6. DEFECT SCHEDULE

CLIENT: THE OWNERS – STRATA PLAN NO. 102187
PROPERTY ADDRESS: 11 MITCHELL AVENUE, JANNALI NSW 2226
BUILDER: TRULAND DEVELOPMENT, FORTE SYDNEY FUND MANAGEMENT, FORTE SYDNEY
CONSTRUCTION, FORTE SYDNEY NSW CONSTRUCTION, XIAOLU LI
DEVELOPER: MITCHELL AVENUE DEVELOPMENT PTY LTD

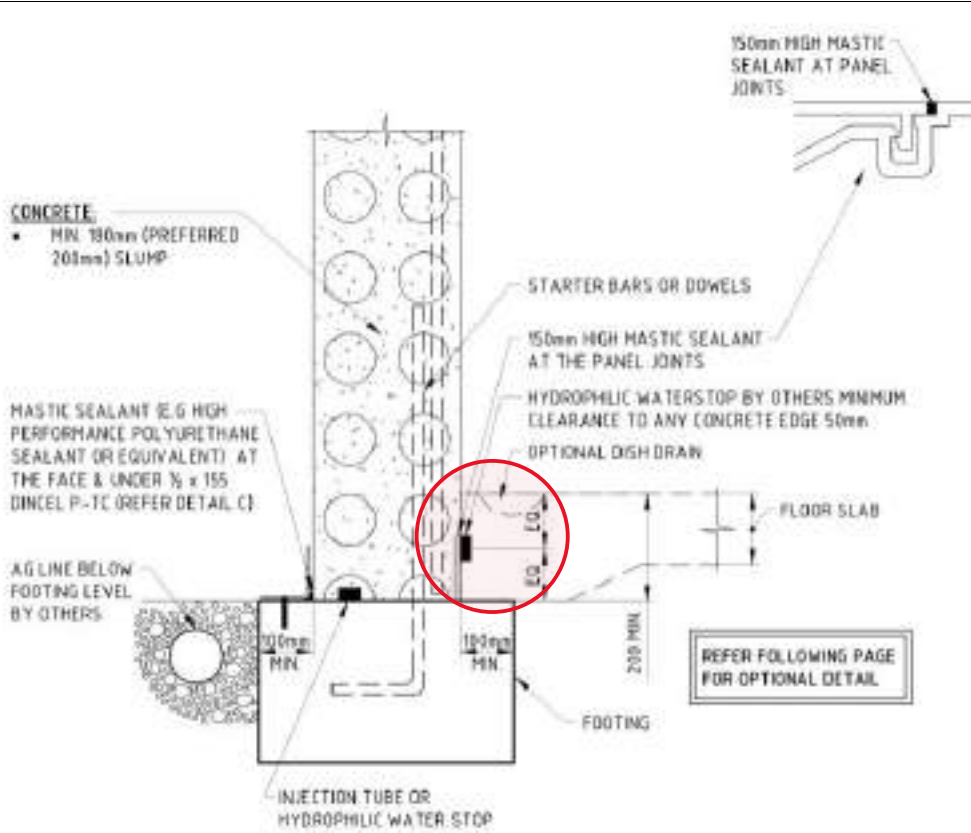
Basement level B1 Southeast stairway – Location of water leak

Basement level B2 Southeast stairway – Location of water leak

Gaps to drain at base of Fire stair door

Drain located at base of external stairs Fire stair door

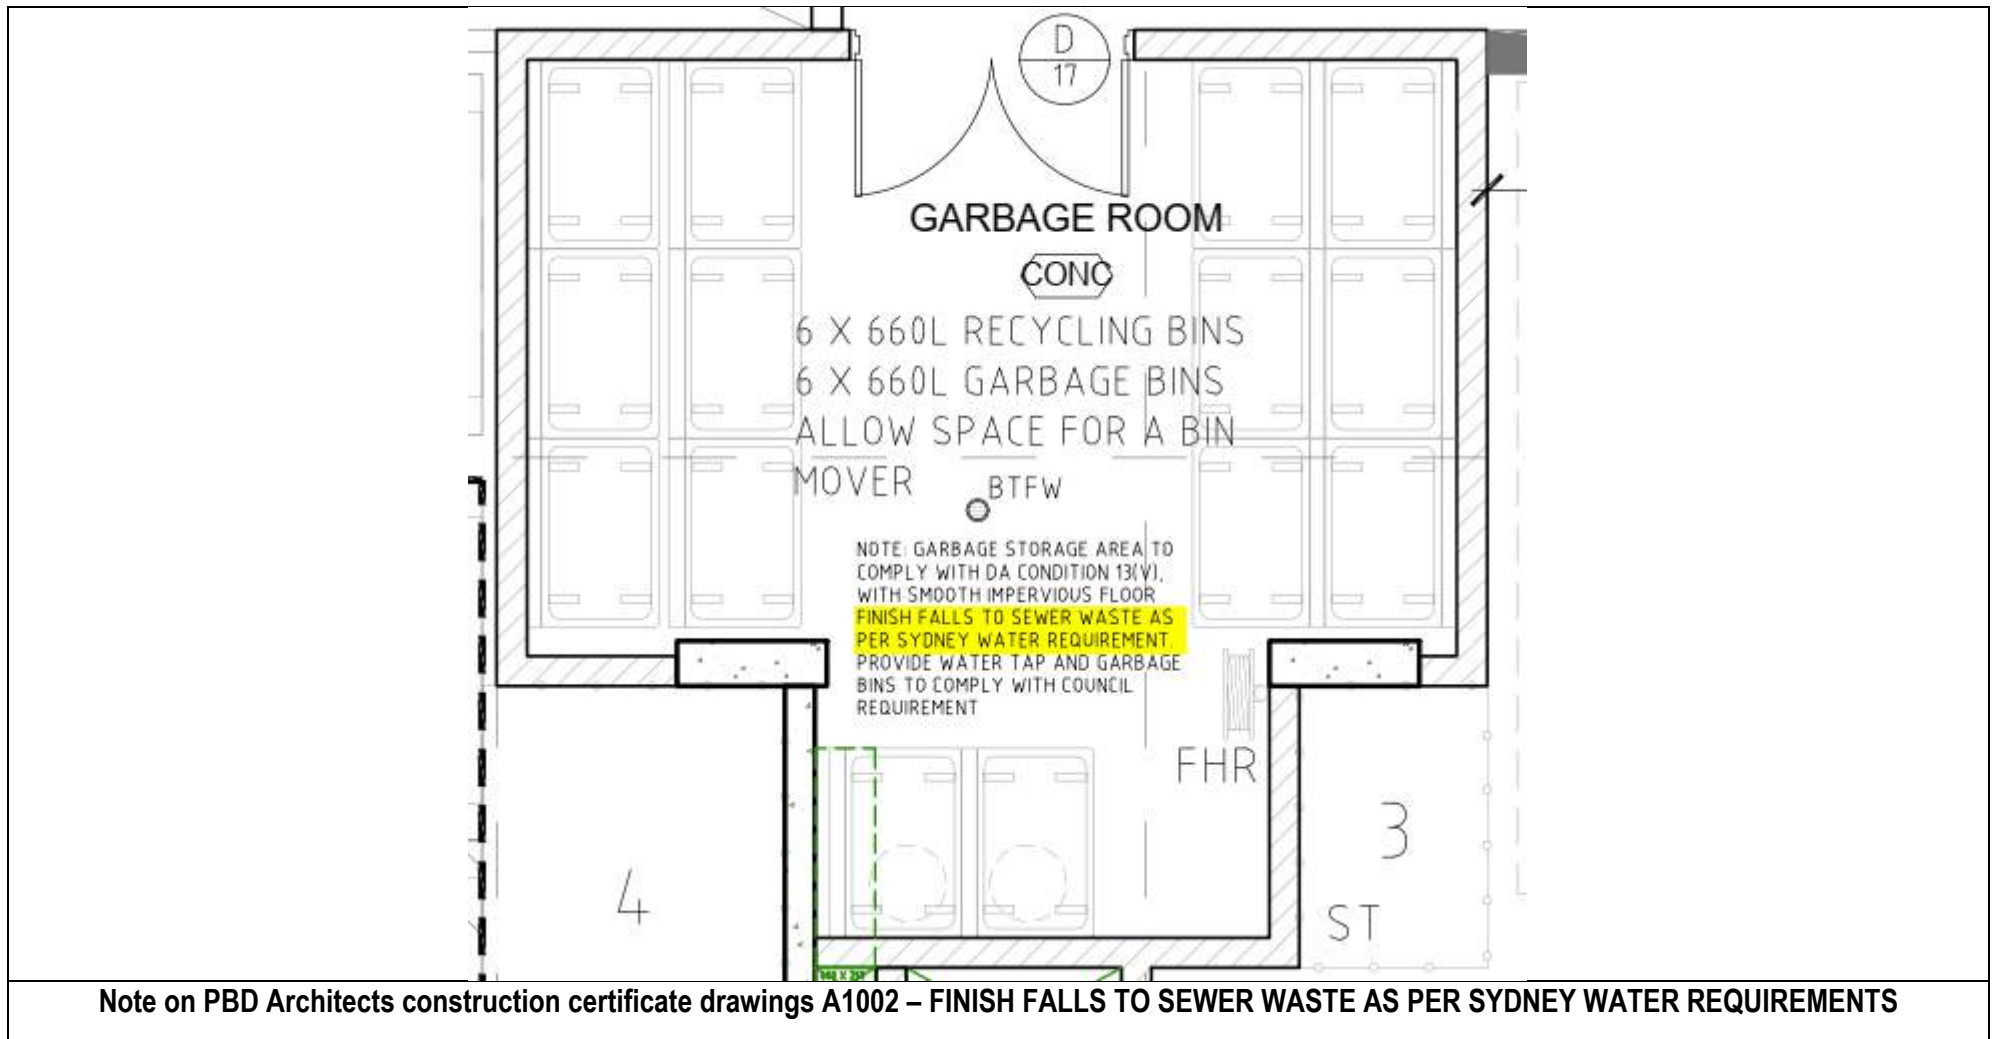
Evidence of bond breaker failure to waterproofing repair at rear of southwest wall of switch room

Evidence of bond breaker failure to waterproofing repair at rear of southwest wall of switch room

Image showing moisture penetrating southwestern masonry wall above waterproofing membrane

Waterproofing membrane terminated approximately 400mm above rear of southwestern wall
